REVISION LOG	
REVISION:001	DATE:10-5-23

Duncans Creek Lot 12
123 Beacon Hill Road
Lillington NC 27546

The Hanover Craftsman - LH

Matt Riley redlines 2.25.2024
J Jones revised 3.11.2024

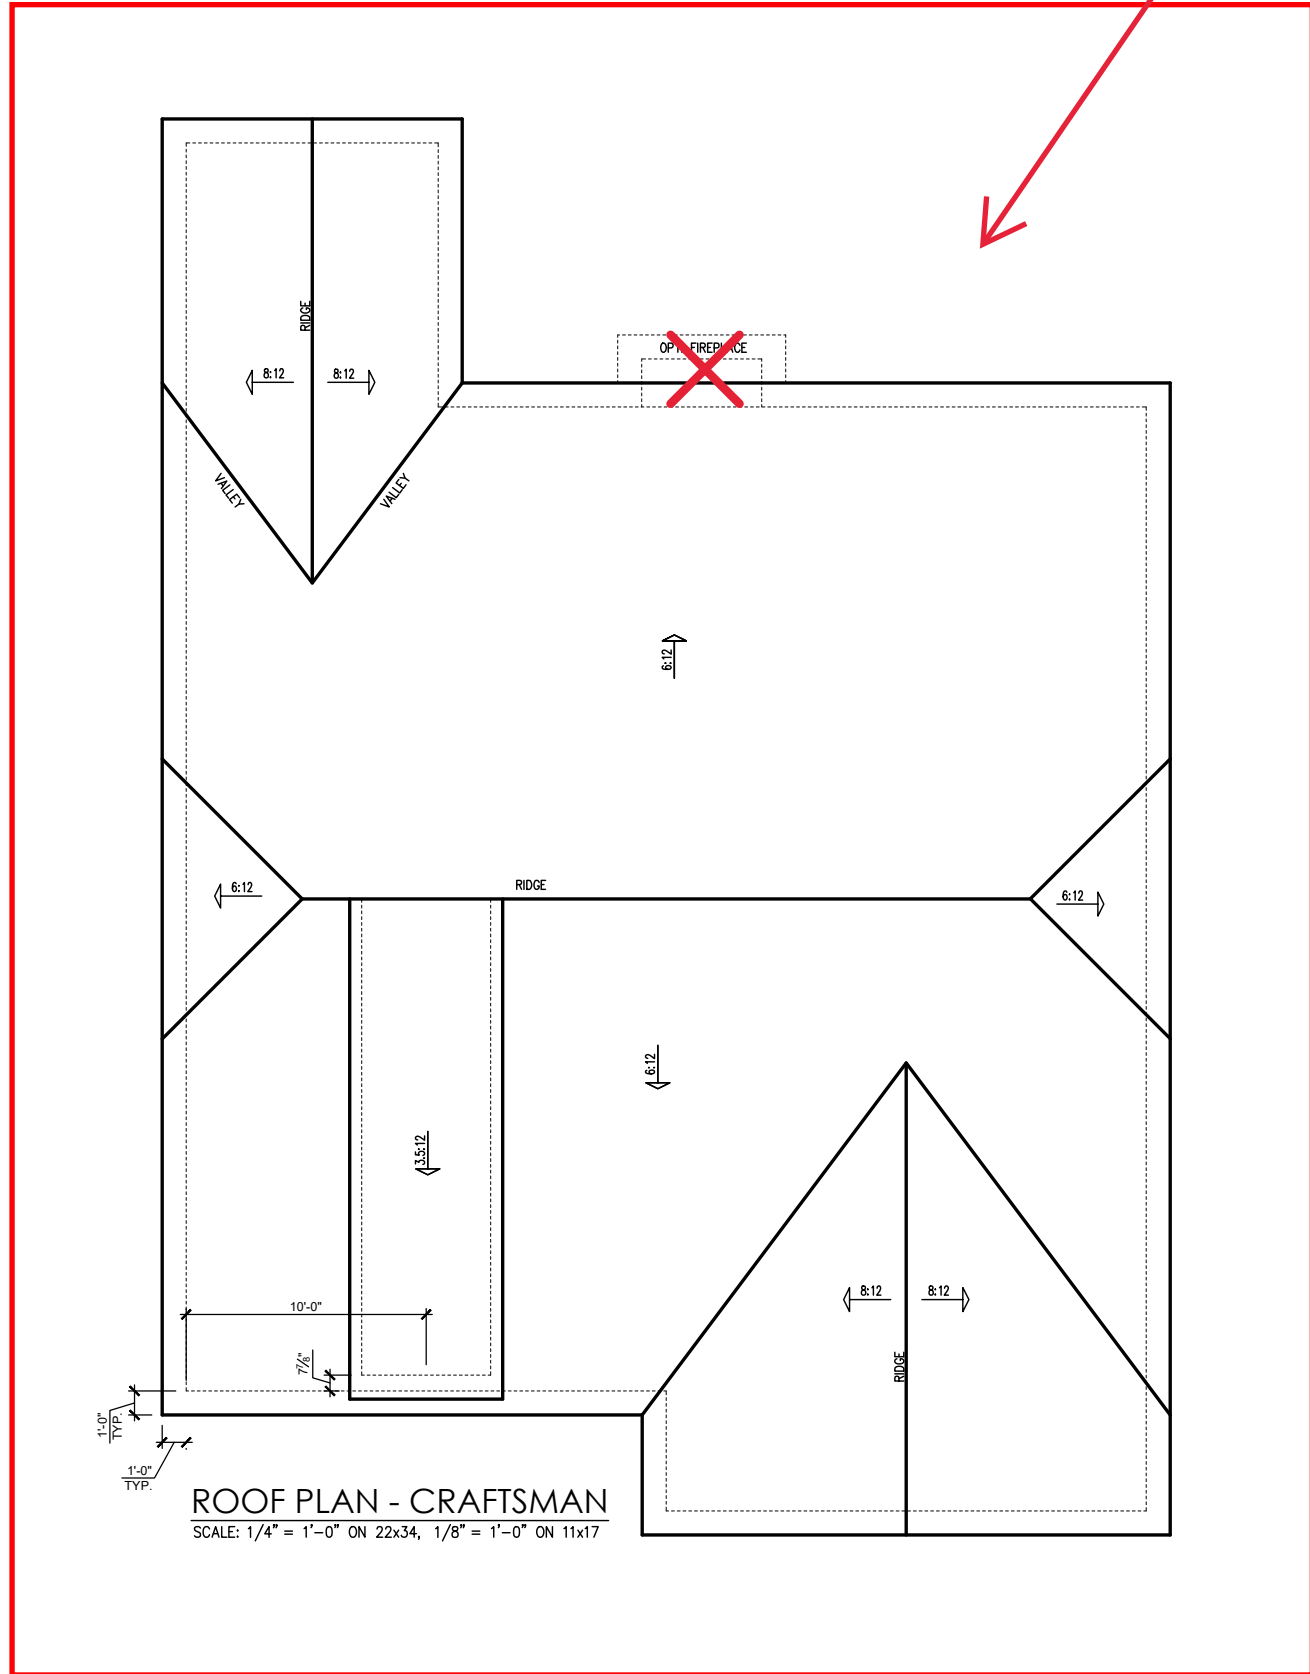
Added Cafe

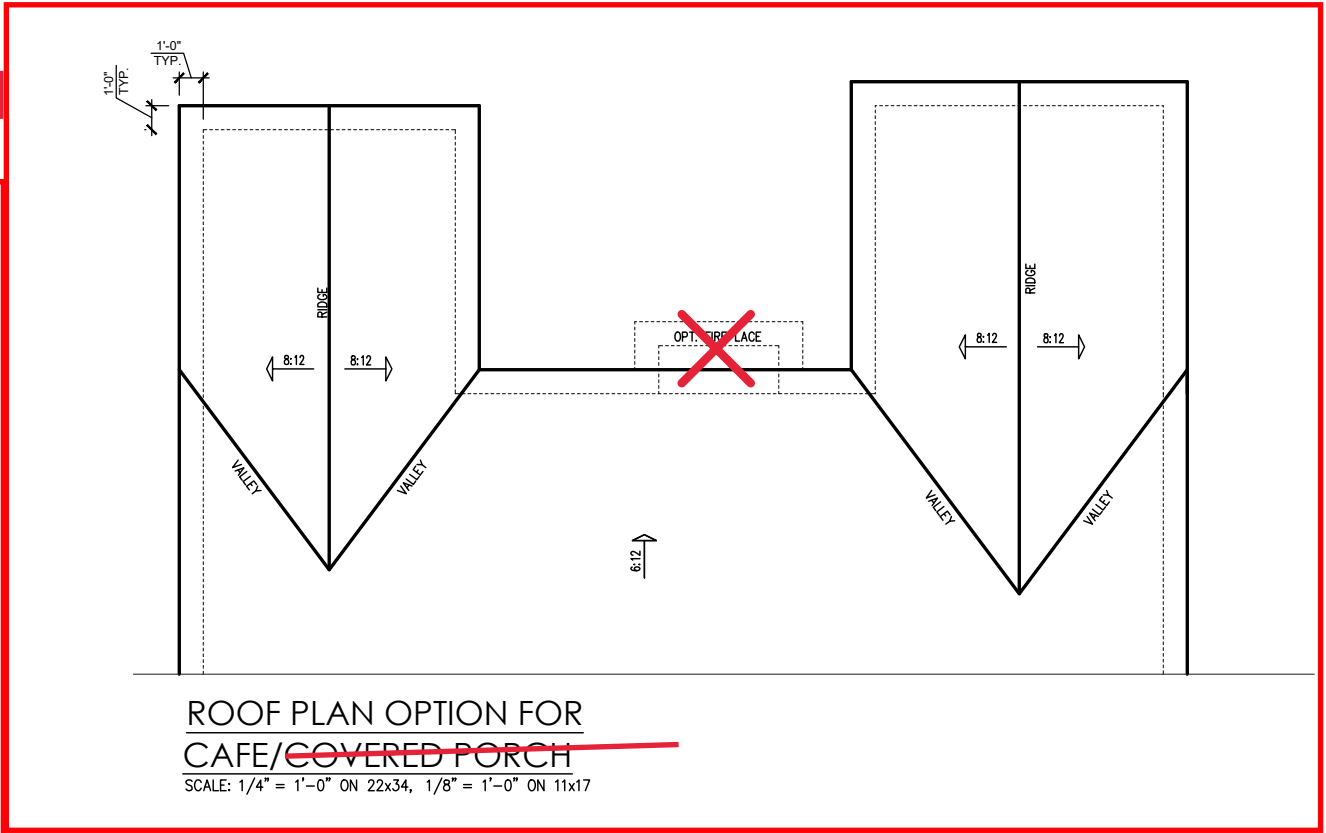
42"x42" Fiberglass Pan Shower w/ bench and Tile walls

CRAFTSMAN FOUNDATION PLAN

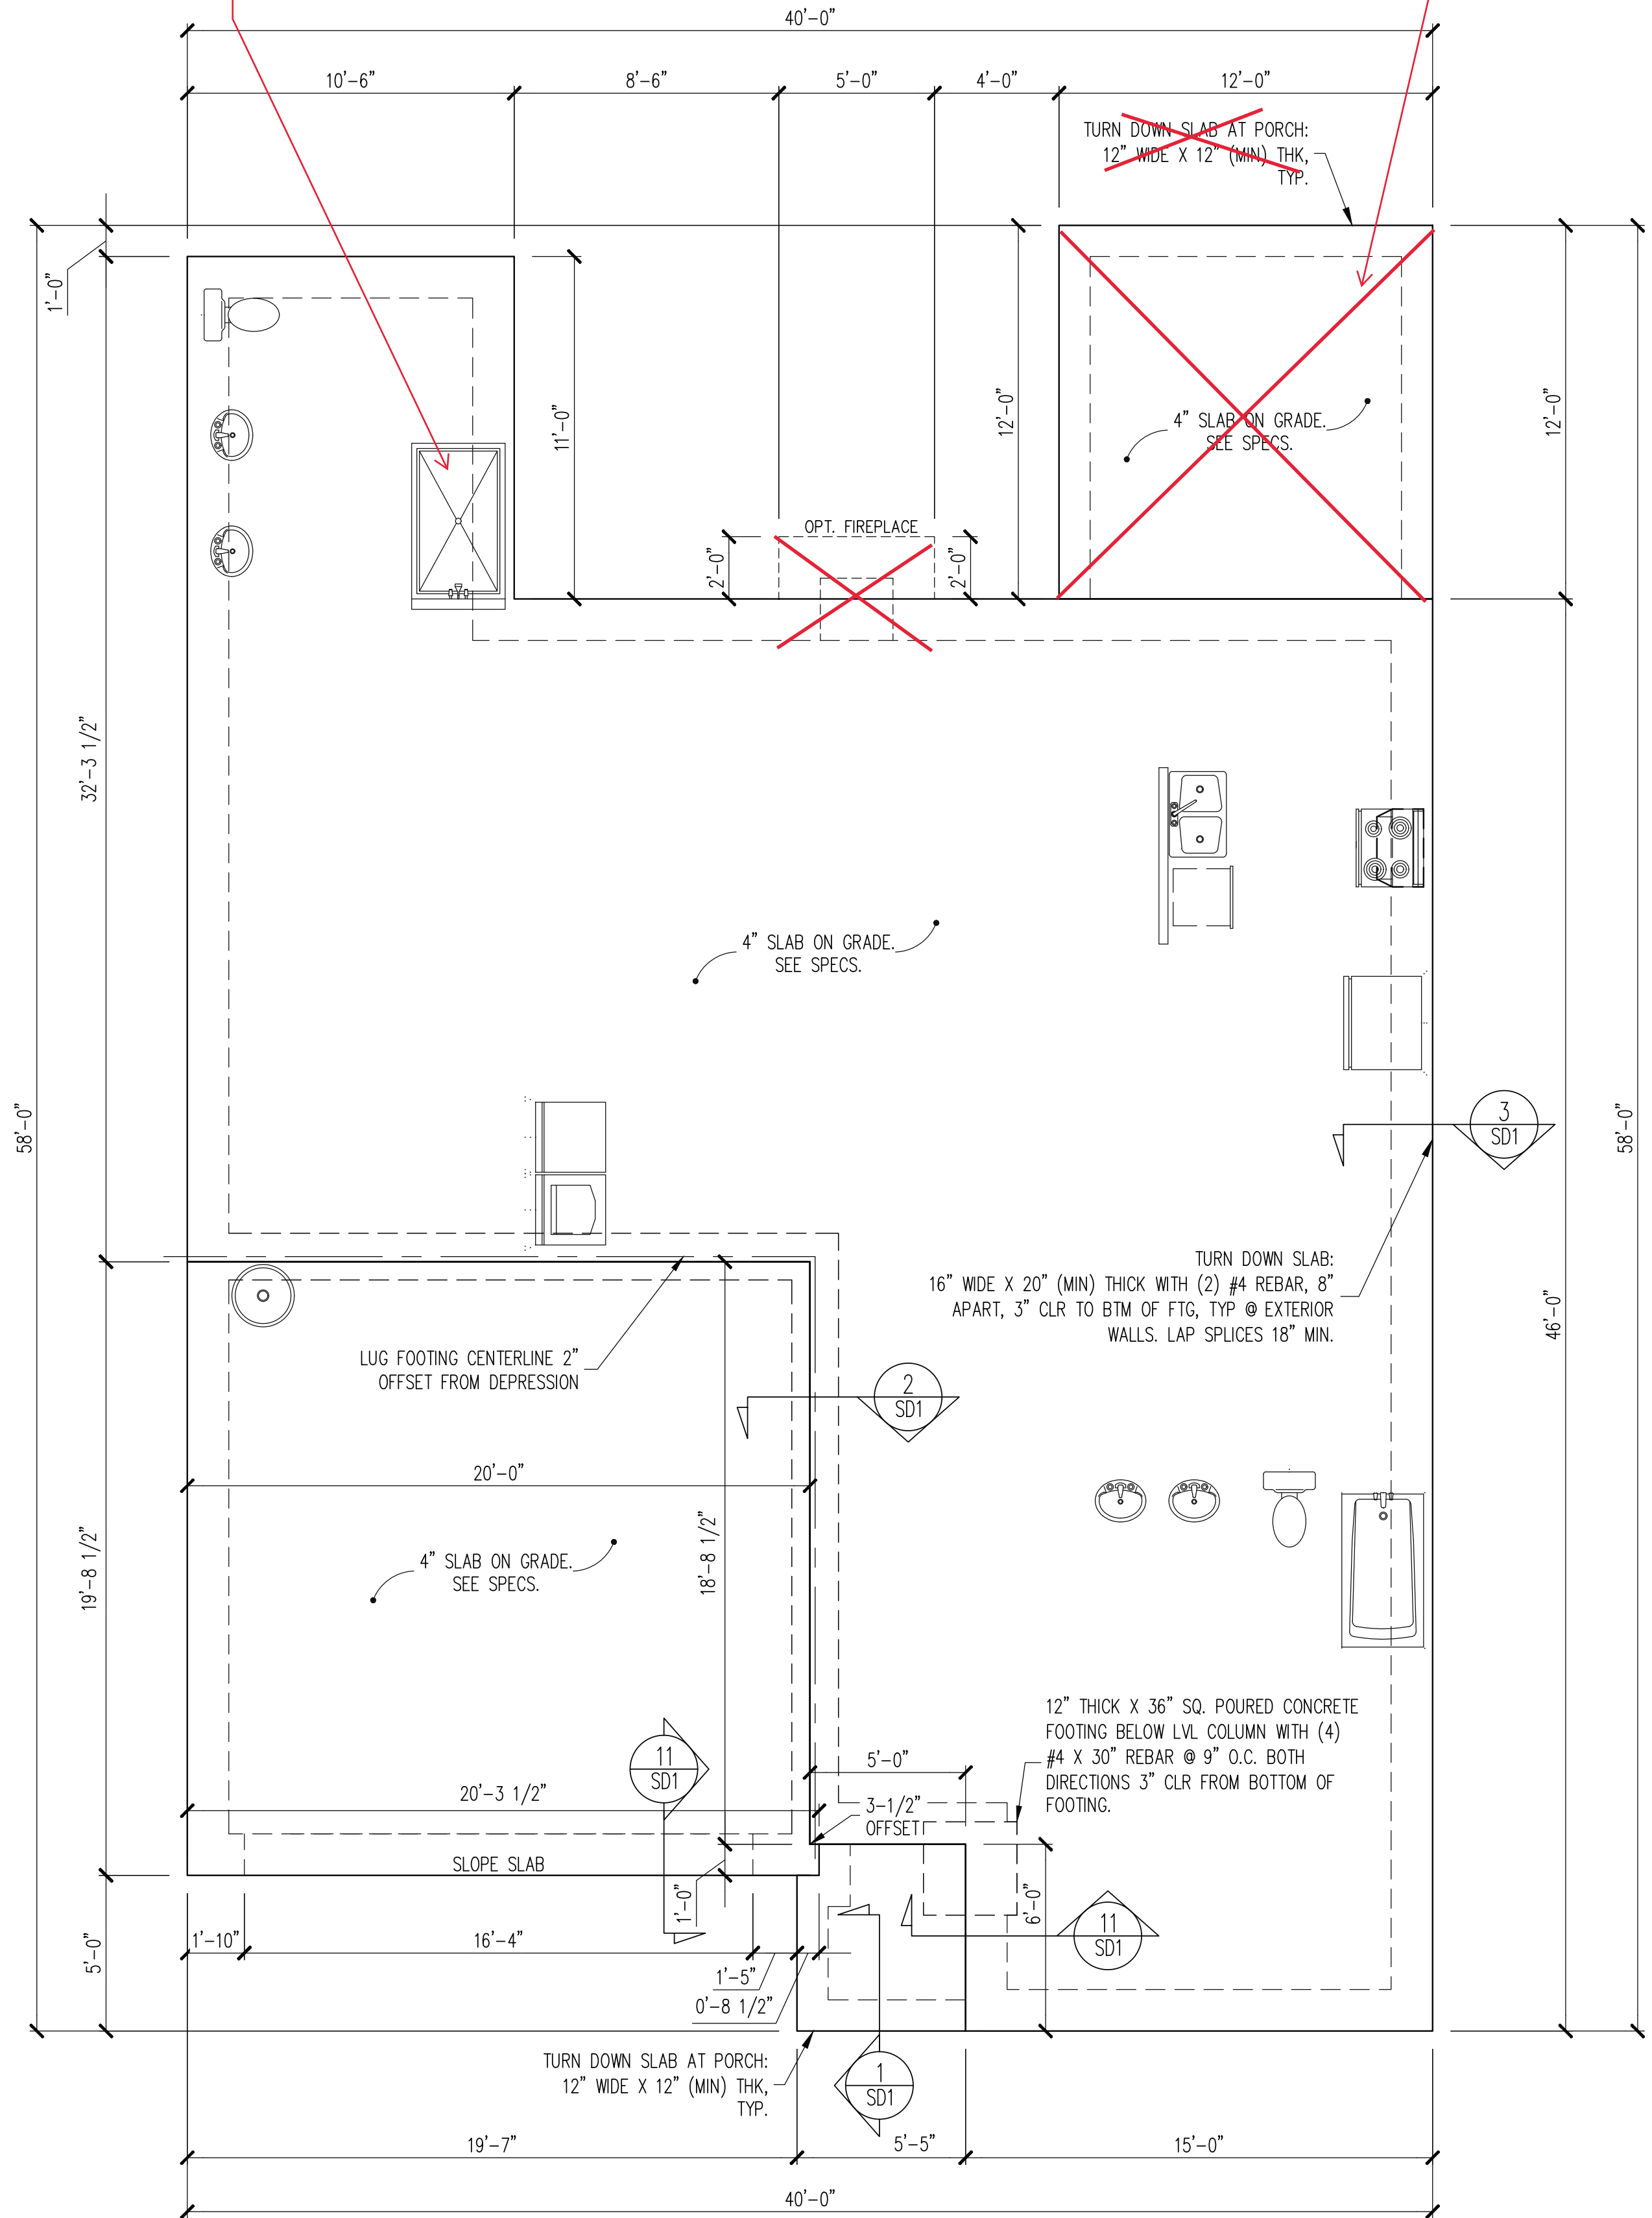
Cafe Bump out addition
